Access Compliance Report

Intersection ID: 10589	Main Street: N_GRAHAM_ST	Cross Street: ARMOUR_DR	Location: SE
ADA ID: CFF5E1CF2D40	Ramp Type: PerpDiag	Initial Pass/Fail: Fail	Overall Compliance: No
			Severity Score: 13.75

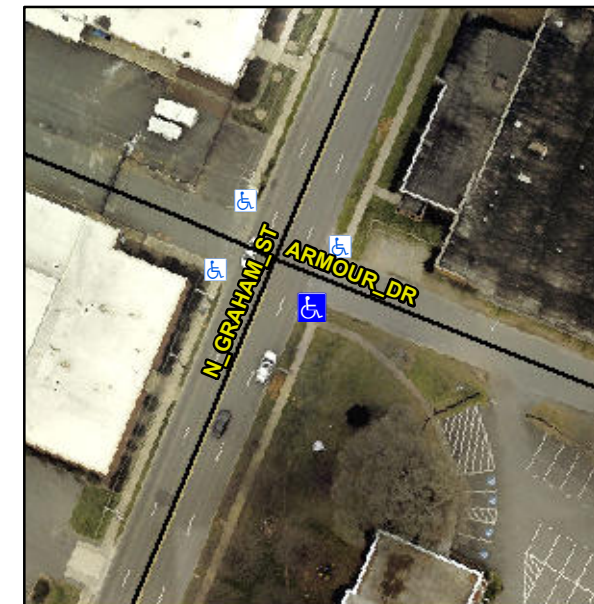
Not Found, R304.2.2, R304.5.3

Compliance	Description	Data	Compliance	Description	Data
N/A	Ramp Length (in)	86.0	No	Ramp Slope (%)	8.4
Yes	Ramp Width (in)	48.0	No	Ramp XSlope (%)	4.6
N/A	Flare Type LT	N/A	N/A	Flare Type RT	N/A
N/A	Flare Slope LT (%)	N/A	N/A	Flare Slope RT (%)	N/A
N/A	Flare Traversable LT?	N/A	N/A	Flare Traversable RT?	N/A
N/A	Landing Length (in)	N/A	N/A	DWS Provided?	N/A
N/A	Landing Width (in)	N/A	N/A	DWS Contrast?	N/A
N/A	Landing Slope (%)	N/A	N/A	DWS Length (in)	N/A
N/A	Landing X Slope (%)	N/A	N/A	DWS Full Width?	N/A
N/A	Landing Curb? (Y/N)	N/A	N/A	DWS Offset (in)	N/A
N/A	Shared Landing?	N/A			
N/A	Gutter Ponding?	N/A	N/A	Gutter Slope (%)	N/A
N/A	Gutter Lip Ht (in)	N/A	N/A	Gutter X Slope (%)	N/A
N/A	Painted X Walk1?	No	N/A	Painted X Walk2?	No
	X Walk 1 Direction	To NE		X Walk 2 Direction	To NW
N/A	X Walk 1 Width (in)	N/A	N/A	X Walk 2 Width (in)	N/A
	X Walk 1 Slope (%)	0.9		X Walk 2 Slope (%)	6.5
	X Walk 1 X Slope (%)	5.4		X Walk 2 X Slope (%)	0.0

Remove & Replace Curb Ramp With Two New Directional Ramps or Equivalent.
